DEFENSE NUCLEAR FACILITIES SAFETY BOARD

**Excerpted Conclusions from the October 1997 Board Staff Report
on the Review of the Hanford Spent Nuclear Fuel Project Schedule Delays**

Review of the Hanford Spent Nuclear Fuel Project

Technical Report

Figure 2
Proposed Schedule for SNFP

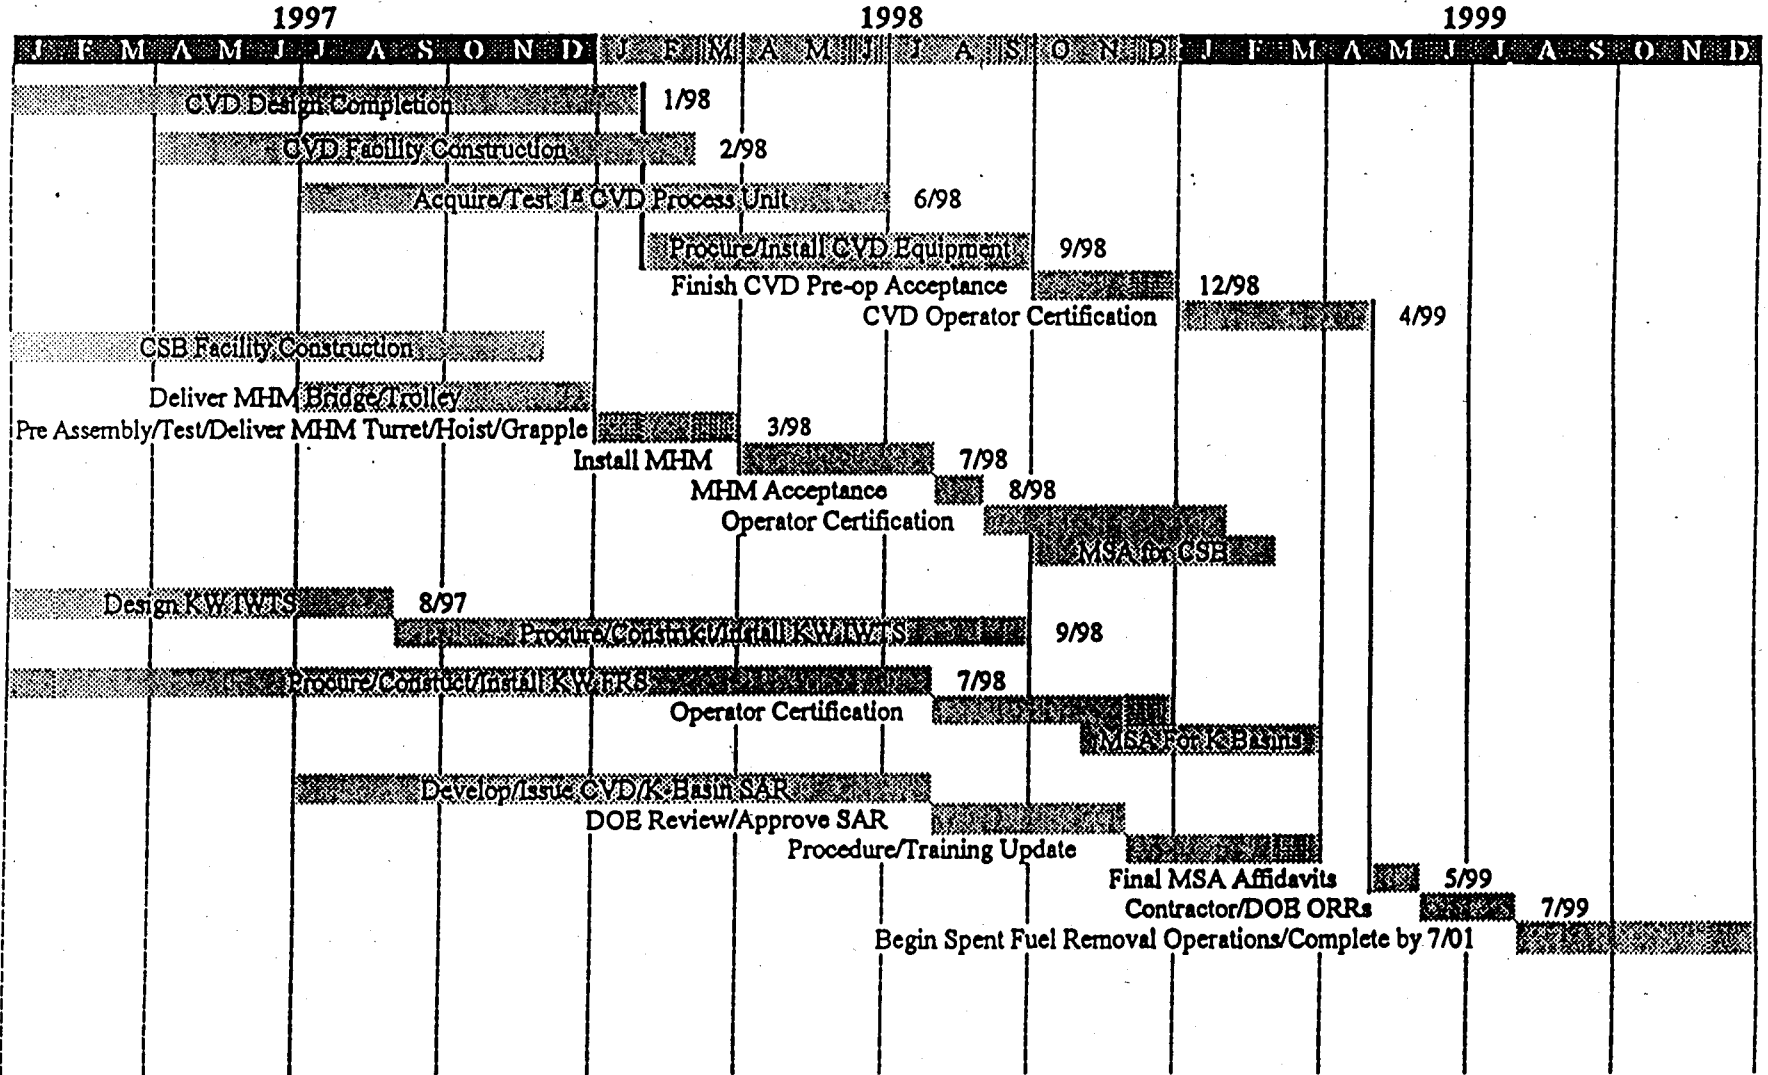
A simplified chart depicting the proposed schedule at a high level is provided in Figure 2. It should be noted that although the CVD subproject was identified by DOE and contractors as being on the SNFP critical path, other subprojects are within a few months of being on the critical path and could easily become pacing items.

Figure 3
SAR Schedule for SNFP

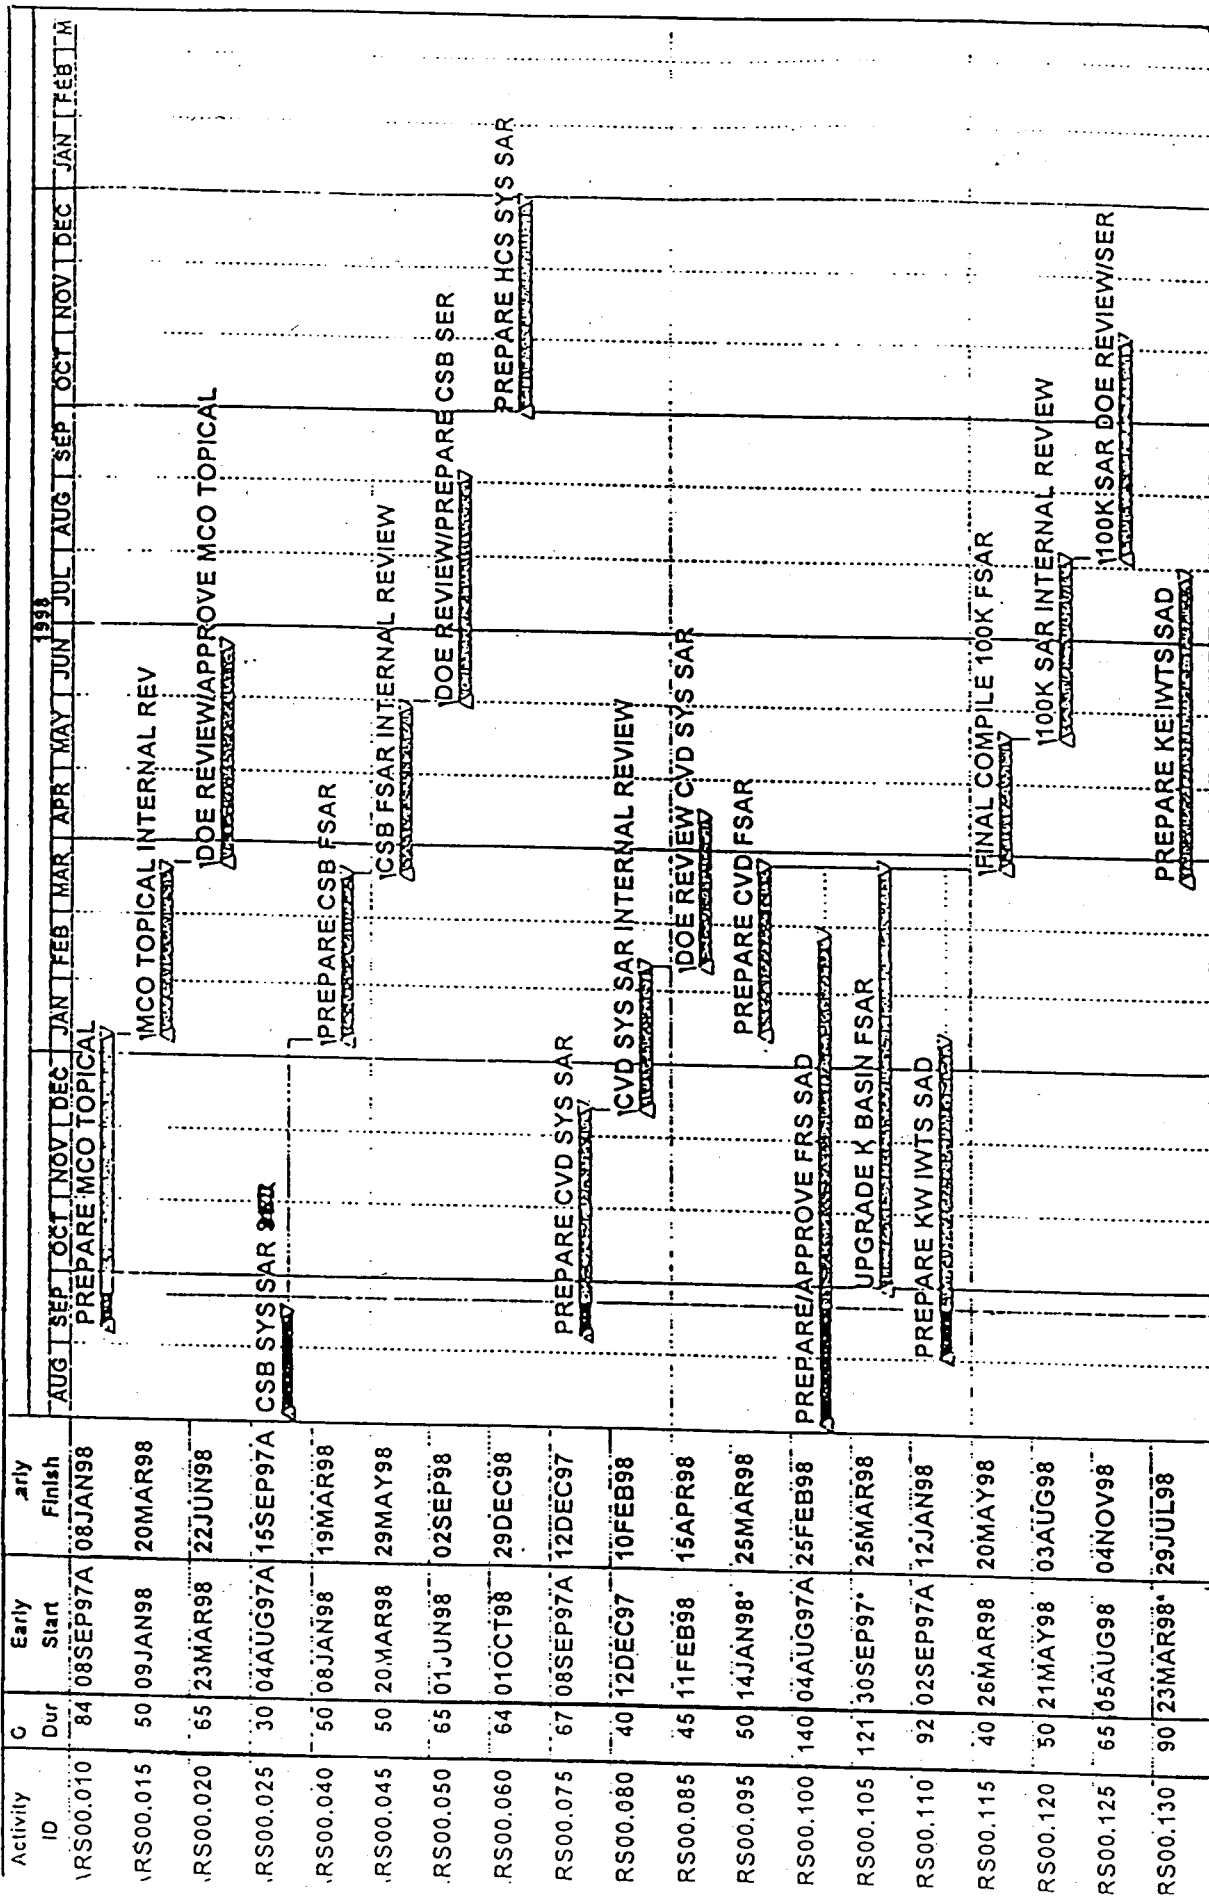
The Board's staff reviewed the SAR/Safety Analysis Documentation subproject milestones as defined in Level 3 schedules to ensure compatibility with the overall SAR schedule for all safety analysis activity (Figure 3). The safety analysis work is not on the critical path, but it drives many activities that are close to being on the critical path, such as procedure development and training. Additional manpower is being secured to ensure timely completion of SARs and to restore DOE-RL's confidence in this activity.
